AMENDMENTS TO FIRE CODE 2018 - 10th BATCH OF AMENDMENTS

SCDF would like to issue the 10th batch of amendments to the Code of Practice for Fire Precautions in Buildings 2018 (Fire Code 2018). The amendments which were deliberated and accepted by the Fire Code Review Committee are attached as Annex A & Annex B of this circular.

Elevation

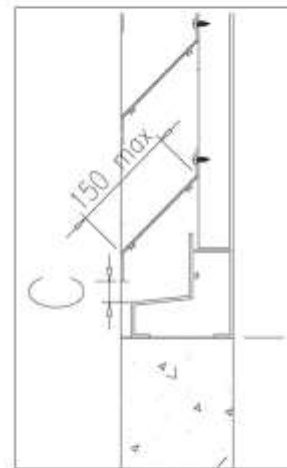
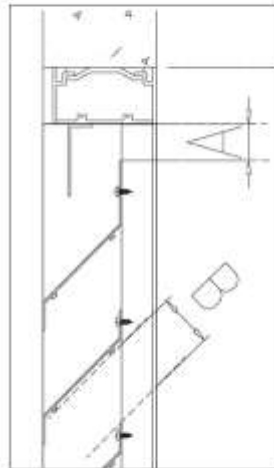
4	1.4.115	01/03/2022	01/09/2022	New	Nil	<p>Ventilation openings</p> <p>“Ventilation openings” refer to fixed natural ventilation openings located in external walls for any space, which shall be unobstructed at all times, and exclude windows or louvres that are openable or operable. The fixed louvres shall consist of a single bank of louvres with blade width not exceeding 150mm, with effective ventilation openings calculated based on the free area calculation stated below:</p>

Ventilation opening size for single bank louvres = Free Area = $L [A + C + (B \times n)]$

- A = Min opening distance between the top frame and top blade
- C = Min distance between the sill and bottom blade
- B = Min distance between blades
- n = Number of B openings
- L = Min distance between louvres (sills)

Diagram 9.6.5b.(5)(c)(i) - Use of fire-rated separating wall between processing area/storage to on-sites facilities

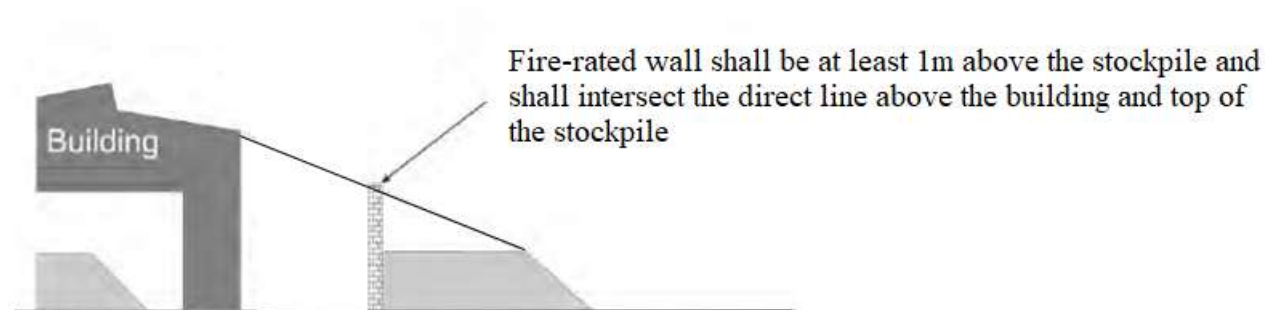
<p>(5) External processing area (open-to-sky)</p> <p>(a) For external area, requirements stipulated in SS 532, e.g., separation distance, provision of fire engine access road, hydrant, etc., shall be complied with.</p> <p>(b) Where separation distance is not able to comply with requirements stipulated in SS 532, use of 4-hr fire resistance rating masonry wall is allowed provided all of the following are complied with:</p> <p>(i) The fire-rated wall shall be at least 1m above the stockpile and shall also intersect the direct line between the on-sites facilities and top of the stockpile. (see <i>Diagram 9.6.5b.(5)(c)(i)</i>).</p>
--	--	--	--	--	--	---

Diagram 9.6.5b(5)(c)(ii): Use of fire-rated separating wall between processing area/storage

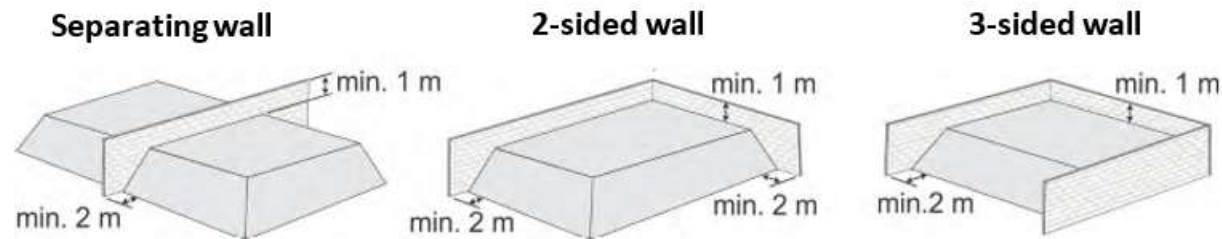
(ii) The fire-rated wall shall be at least 2m beyond the outermost edge of the stockpile. (see *Diagram 9.6.5b.(5)(c)(ii)*).

(iii) When fire-rated wall is used, at least one façade shall remain open for firefighting accessibility.
